Report To
JET PROPULSION LABORATORY
California Institute of Technology
Pasadena, California
JPL Contract No. 956493

EVALUATION OF DSS-14
PEDESTAL-REVIEW OF TOP SURFACE
REPAIR PROCEDURES

May 1983

This report presents results of Construction Technology Laboratories' (CTL) review of proposed repair procedures for the top surface of the pedestal supporting the hydrostatic bearing runner for the 64m Antenna at DSS-14, Goldstone. Proposed repair procedures were prepared by Jet Propulsion Laboratory (JPL).

Fig. 5 Cross Section Through Haunch Area Indicating Existing Reinforcement in Repair Area

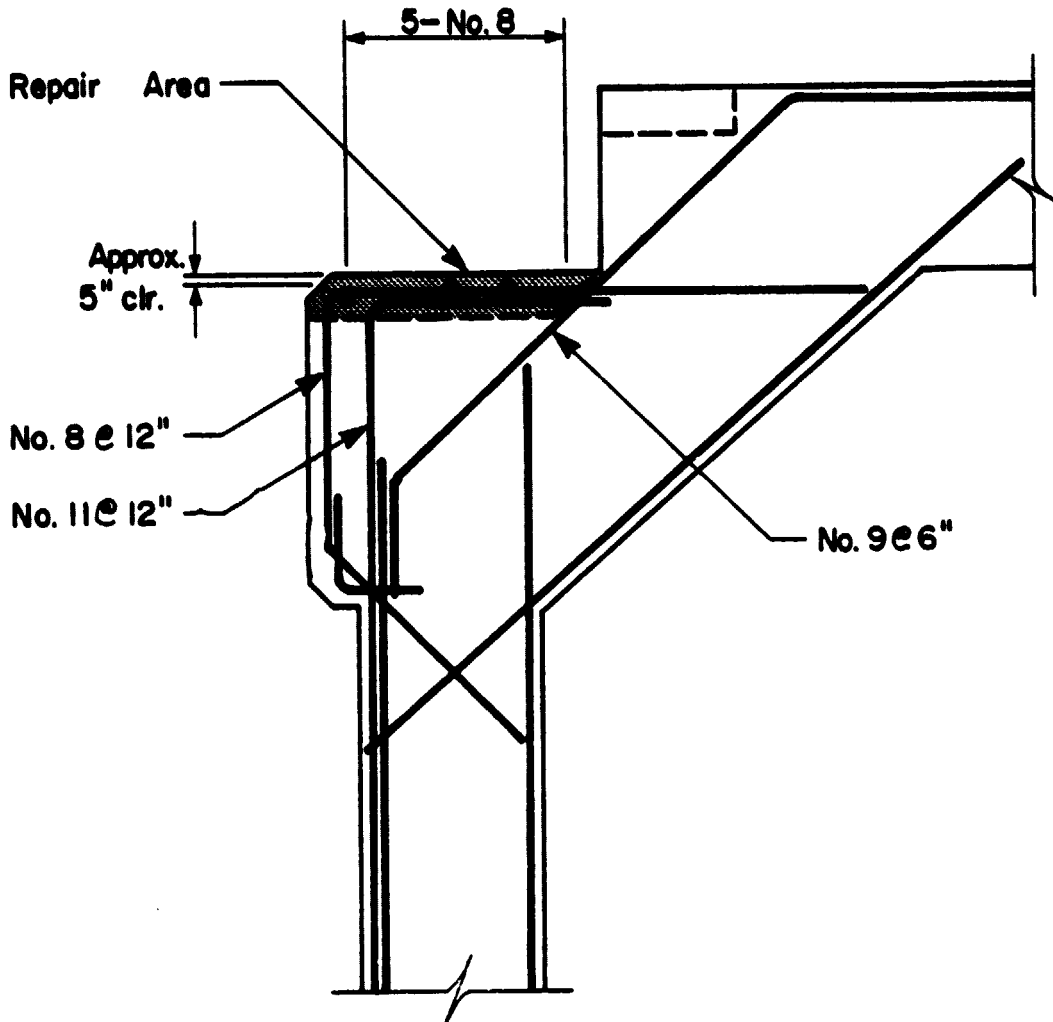
Reinforcement within a section of the haunch region to be repaired is shown in Fig. 5. Staff of JPL indicated that the 8 in. depth was chosen to permit removal of concrete down to approximately 2 in. below horizontal layers of reinforcement in the top surface of the haunch. Review of JPL photograph No. 033916 by CTL indicates that approximately 10 in. of material should be removed to be 2 in. below all reinforcement. This depth however would not alter any removal or replacement techniques.
